**syngo.via RT Image Suite**  
with *syngo.via* VB30 and *syngo.via* VB40 software  
with licence for patient marking with external lasers  
(technical name of the license:  
"CT RT IMAGE SUITE PAT MARK")

Customer Safety Advisory Notice SY051/20/S

**SOMATOM go. CT Scanners with  
syngo.RT Image Suite**  
with *syngo*.CT VA20A, *syngo*.CT VA30A  
with licence for patient marking with external lasers  
(technical name of the license:  
"CT RT IMAGE SUITE PAT MARK")

**Subject: Incorrect calibration offset between CT central image plane and external lasers after update/upgrade potentially resulting in an unprecise cancer treatment**

Figure 1: Warning on page 28 (English version) of user manual *syngo.via RT Image Suite* (Print No. C2-via-RT.621.03.03.02)

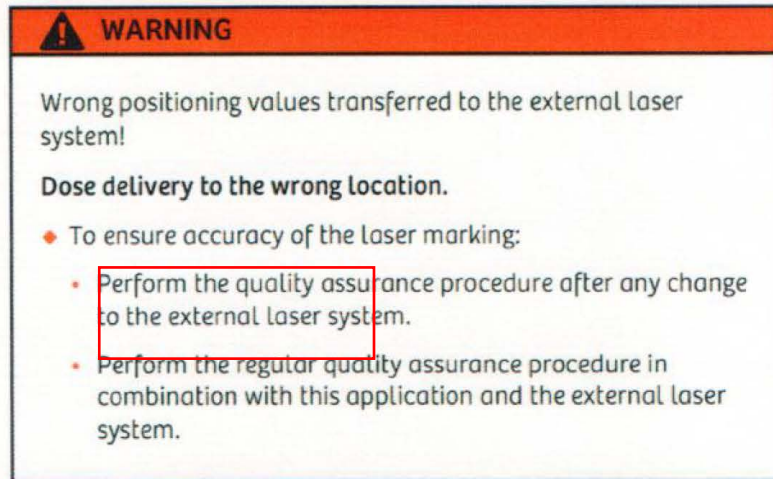
In addition to the already provided recommendation in your user manual (see warning in Figure 1 below), we highly recommend performing the laser calibration and the quality assurance procedure for the laser offset after every RT Image Suite software update.

Figure 2: MM RT Image Suite Configuration dialog with the marked parameter

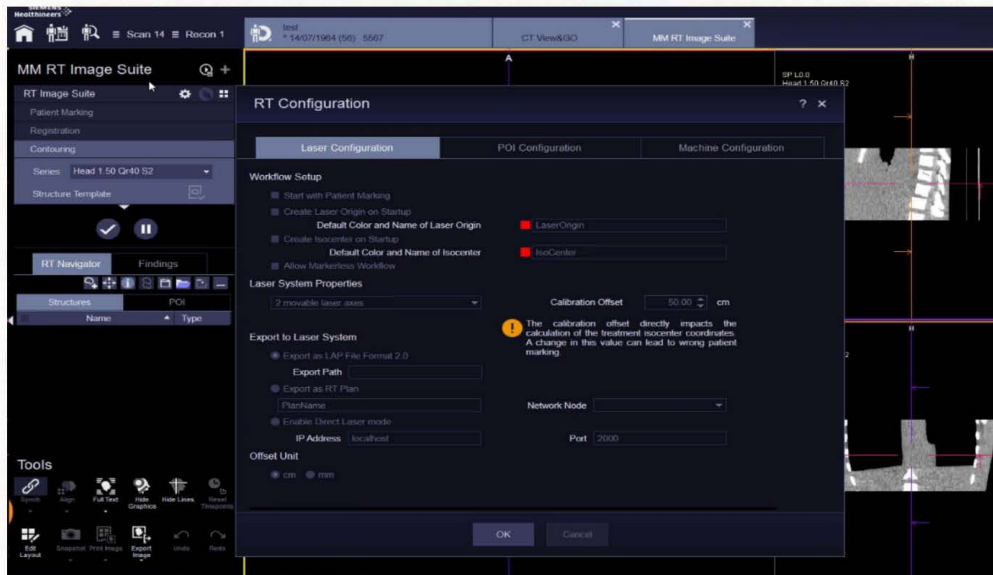
The calibration offset between the central CT image plane and the external RT lasers has been set automatically to the factory default of 50.00 cm, if your *syngo.via* RT Image Suite has been updated or upgraded to one of the following software versions:  
- *syngo*.CT VA20A to *syngo*.CT VA30A  
- from any lower *syngo.via* SW-version to *syngo.via* VB40

Please update the calibration offset in the MM RT Image Suite Configuration dialog accordingly as shown below in Figure 2. Details of this procedure are documented in Chapter 13.2 (Laser configuration) of your user manual.

The described issue has already been corrected with the update package to *syngo.via* VB40B\_HF01. All other update packages will not be rolled out via remote connection anymore, but with support by your local service organization.
